STERLING RANCH ROAD & BRIARGATE PARKWAY STORM PLANS

STORM SEWER PLANS

PCF FILING NO.: CDR 221

v4_CDs Storm.pdf Markup Summary

DP12 PROFILE(8)
STA 56+00.00 TO 60+36.64
PRIVATE (SRMD)

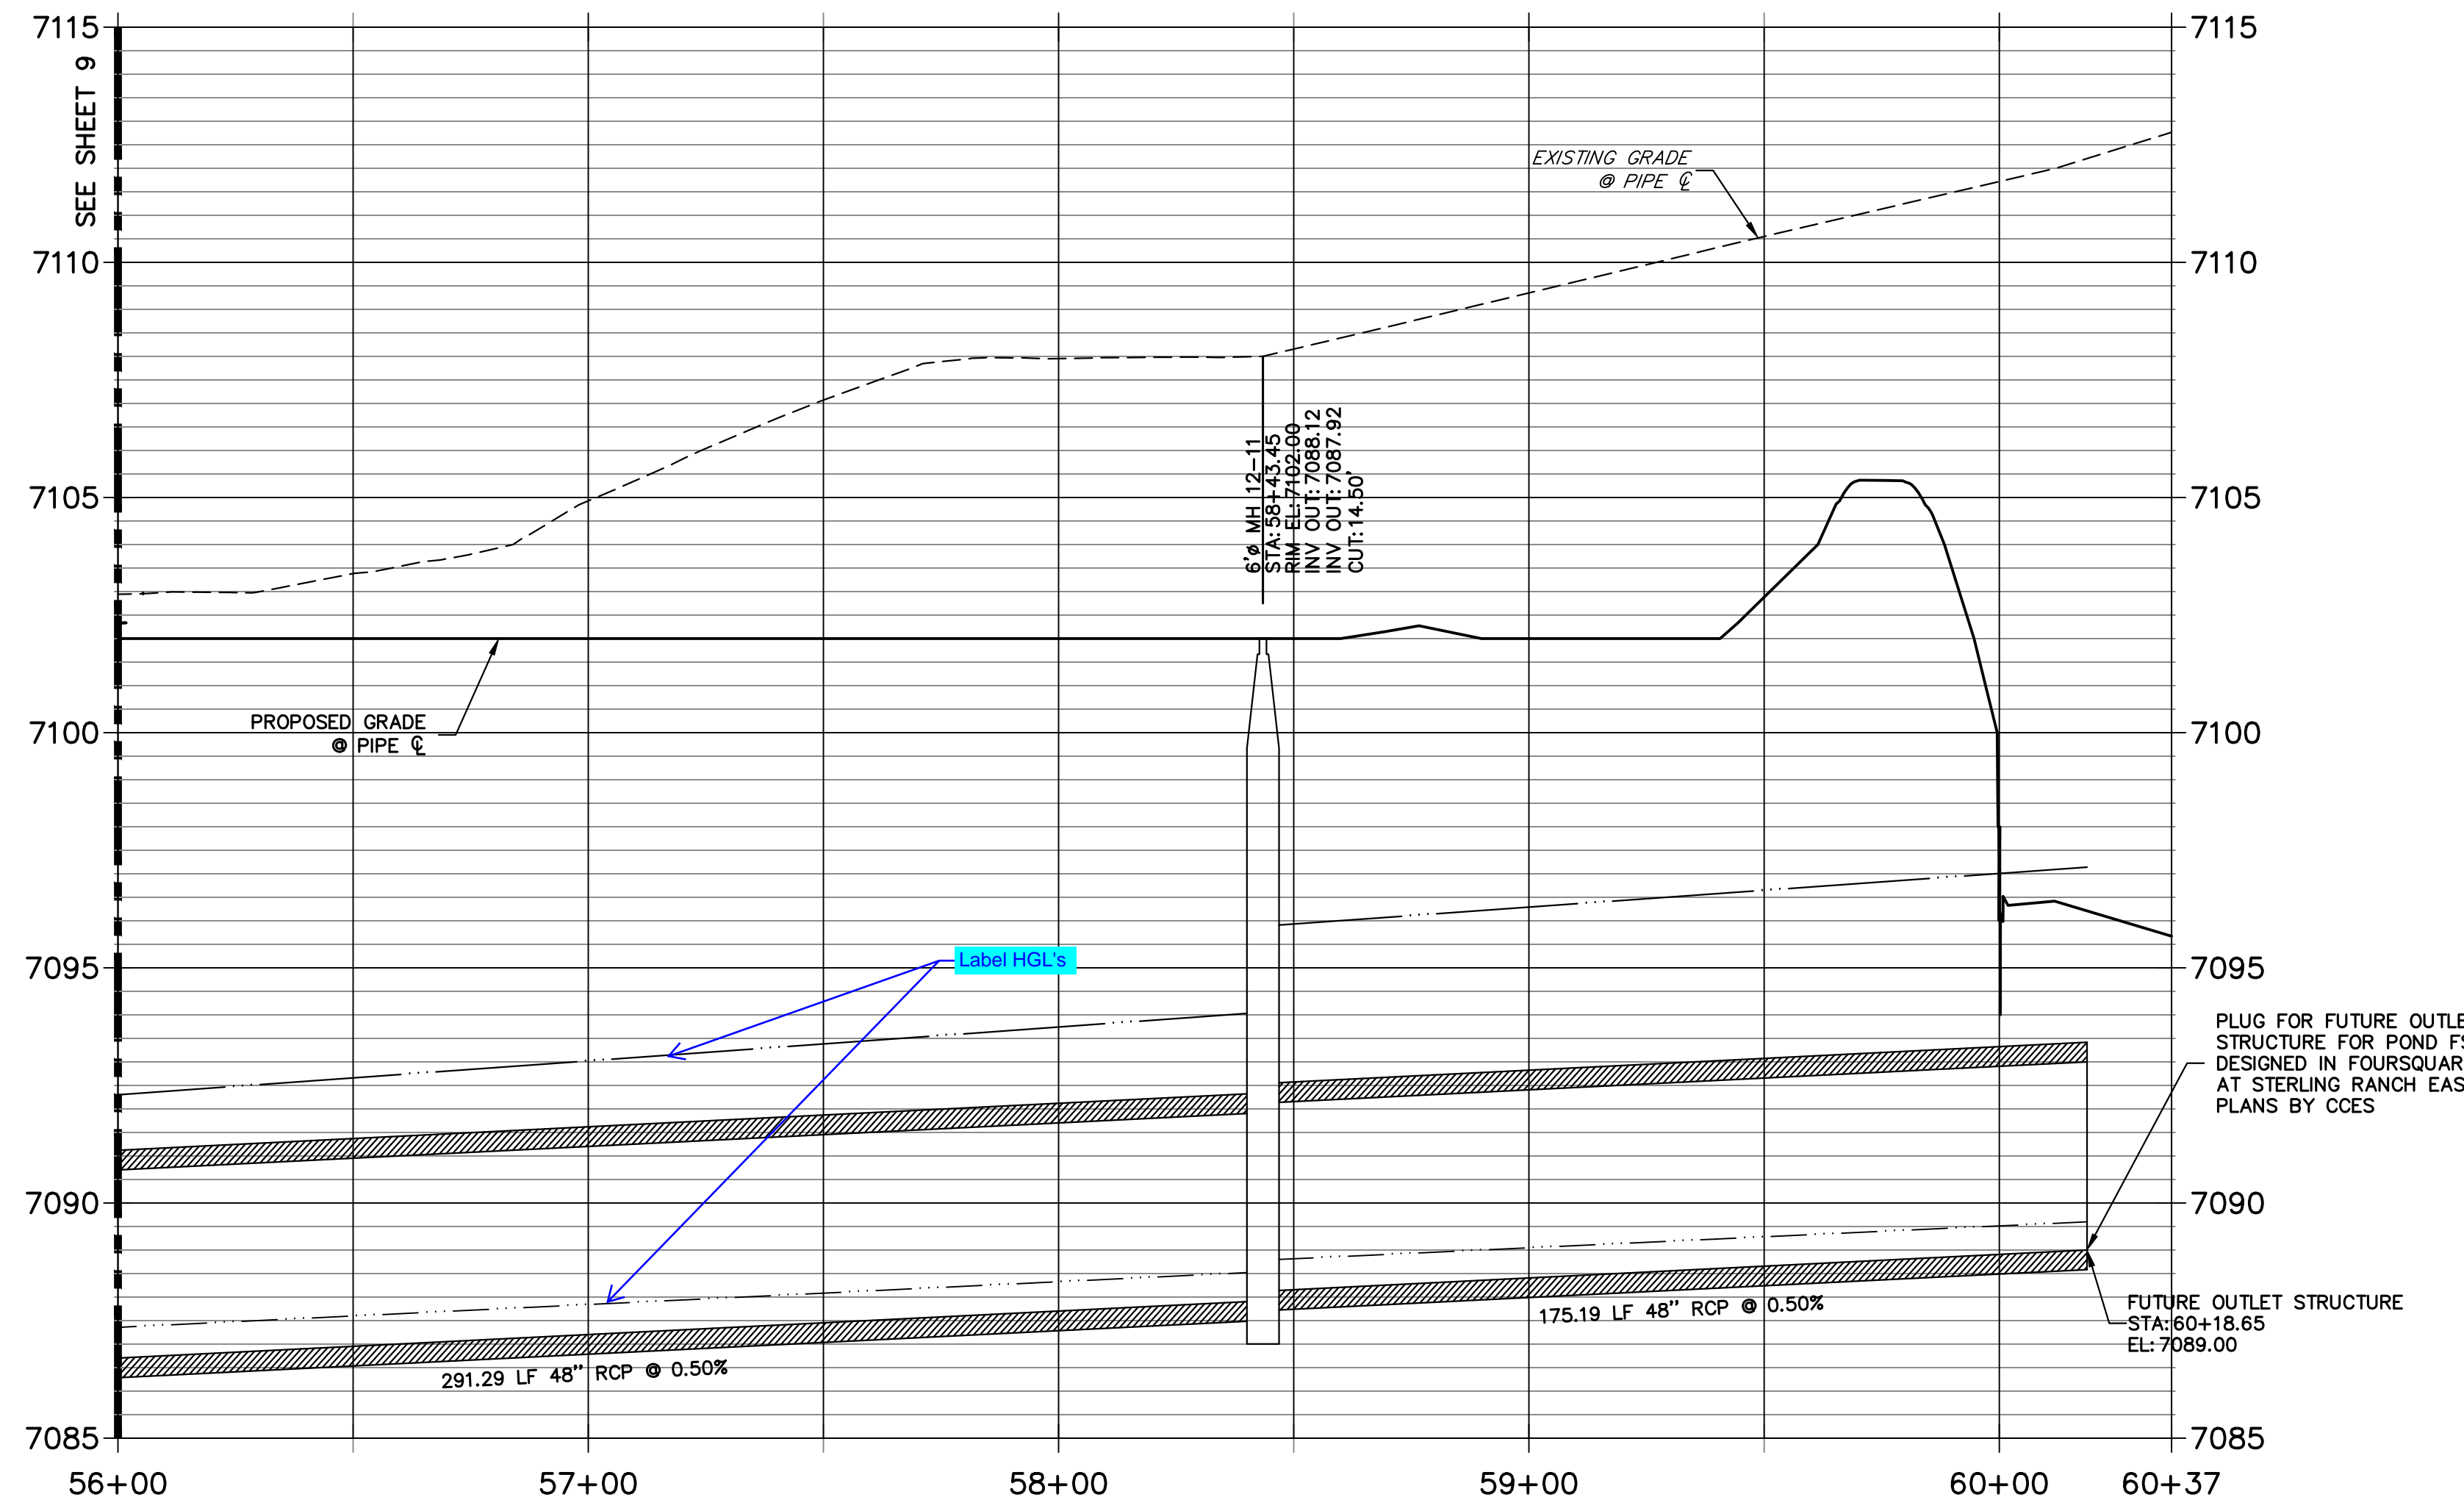
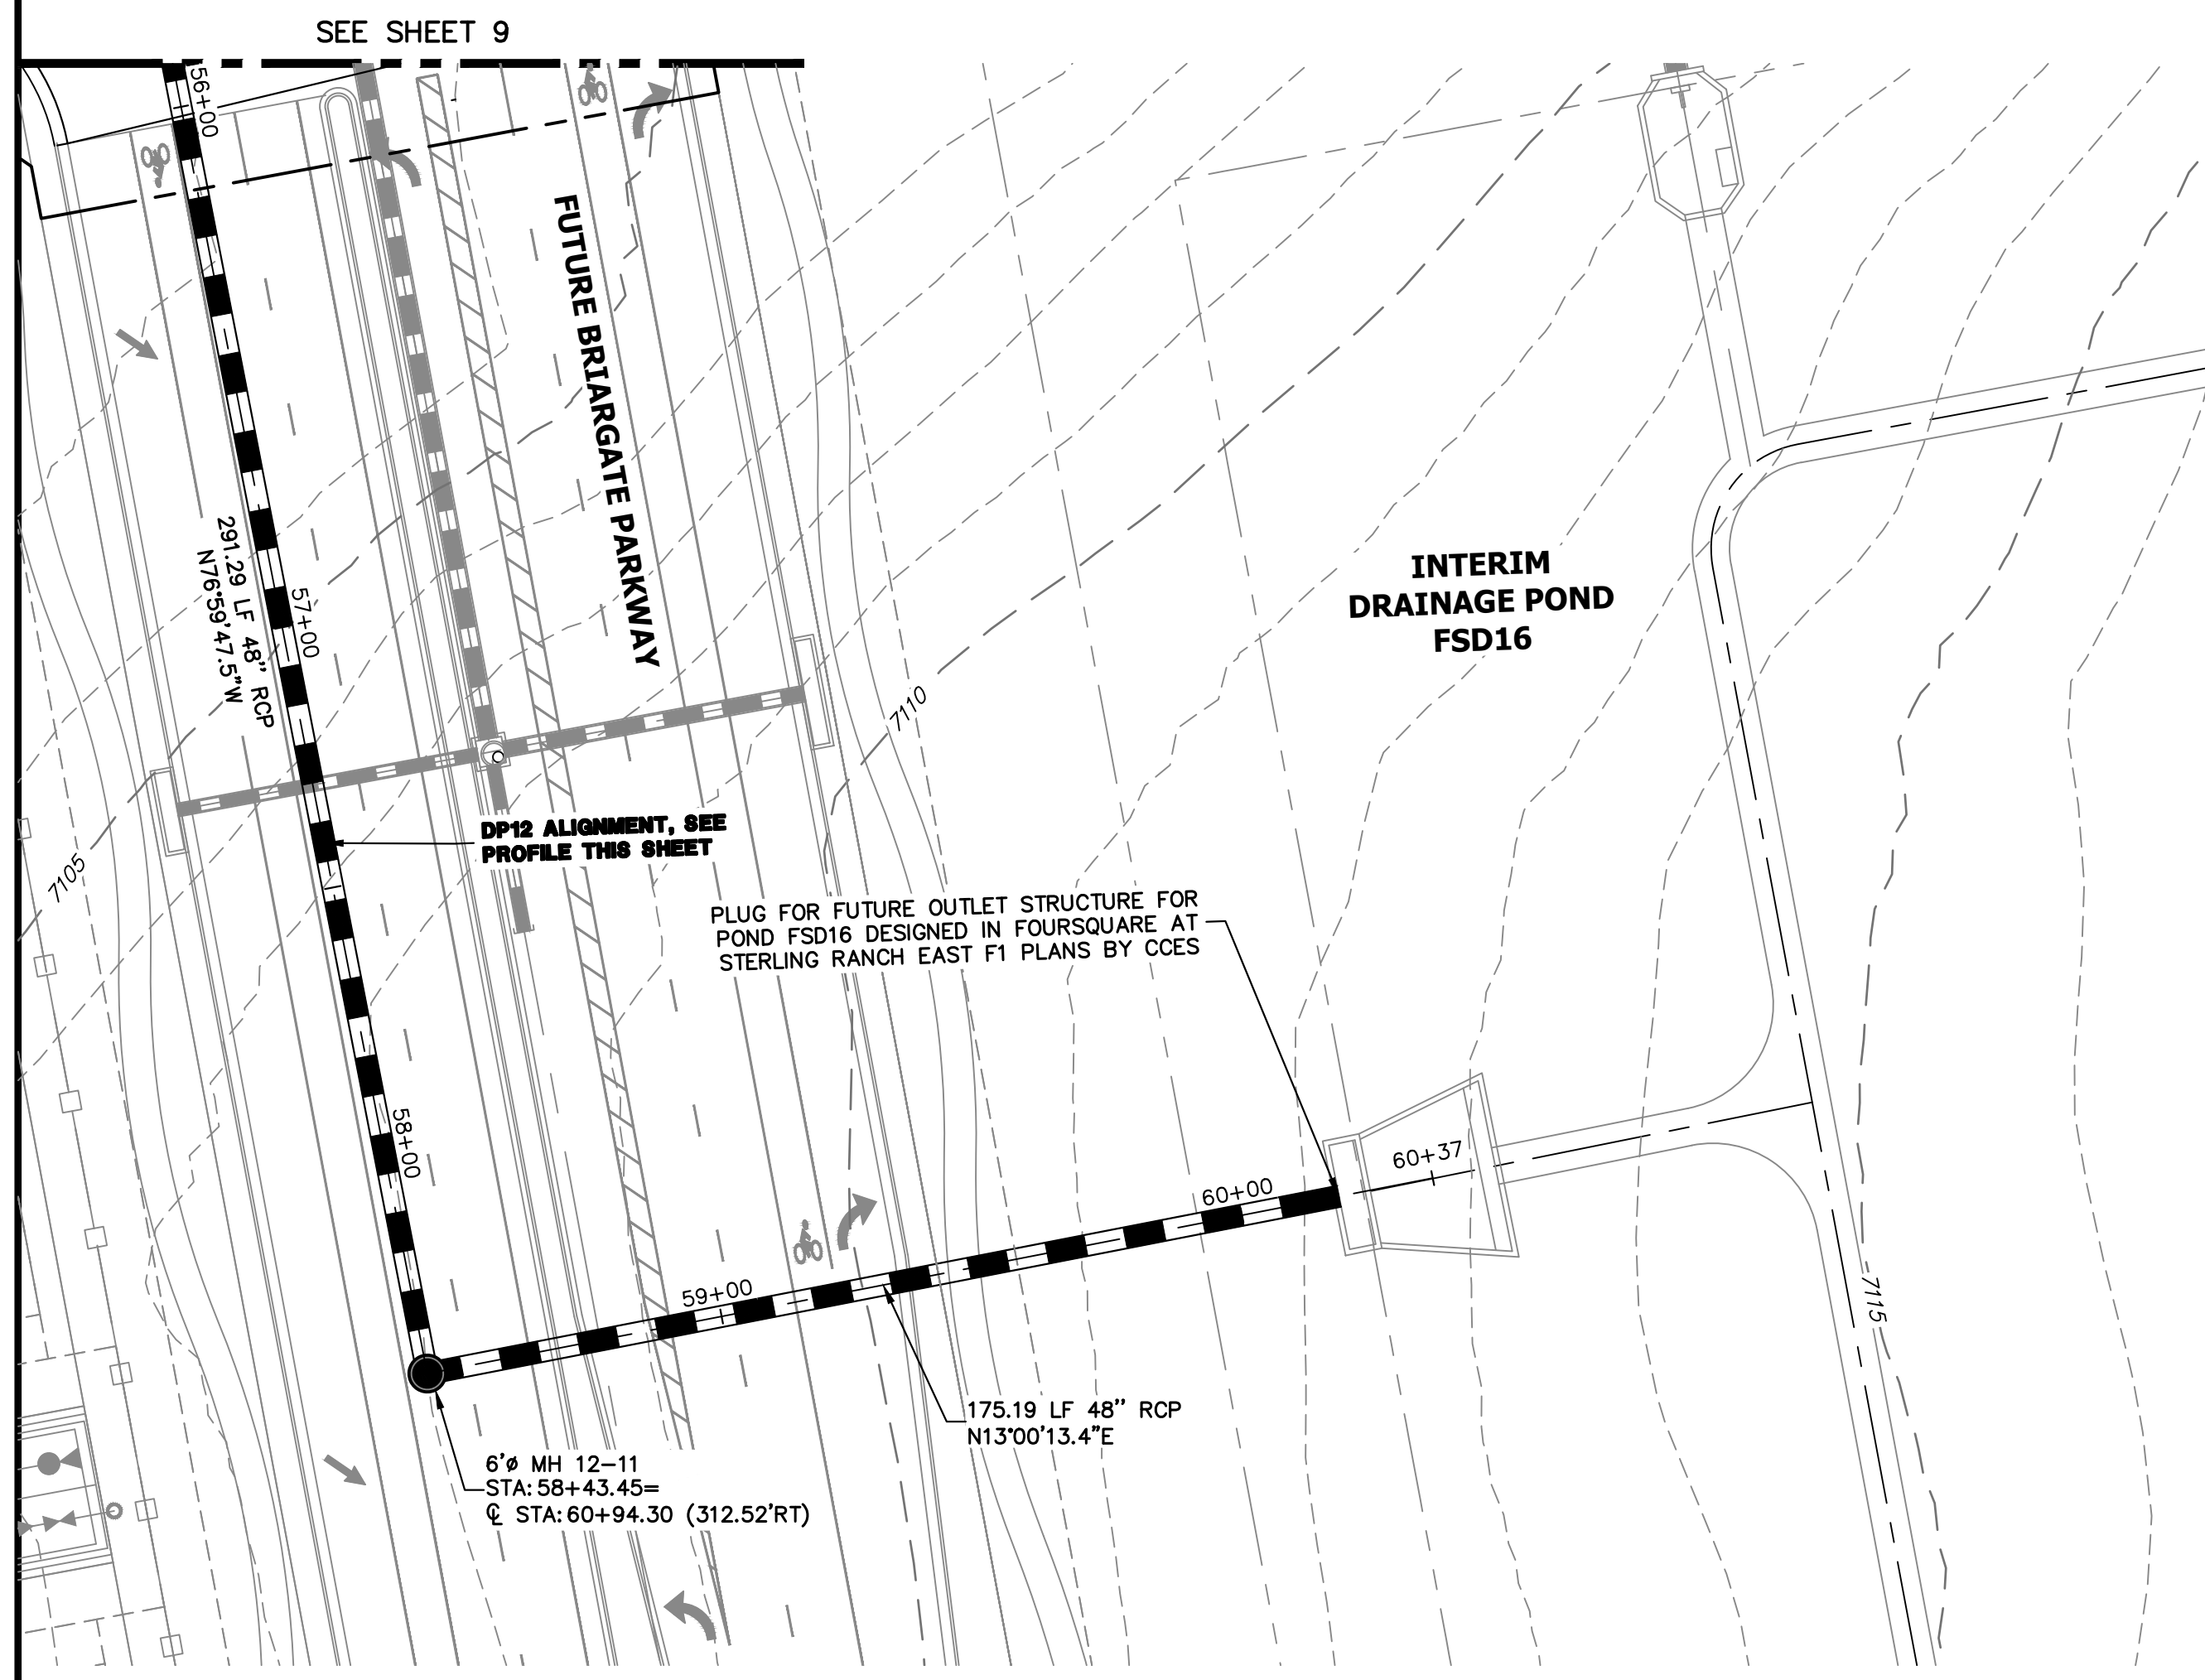
Label HGL's

Inv Out labeled higher than Inv In

Label Inv

Water crossing per plan view
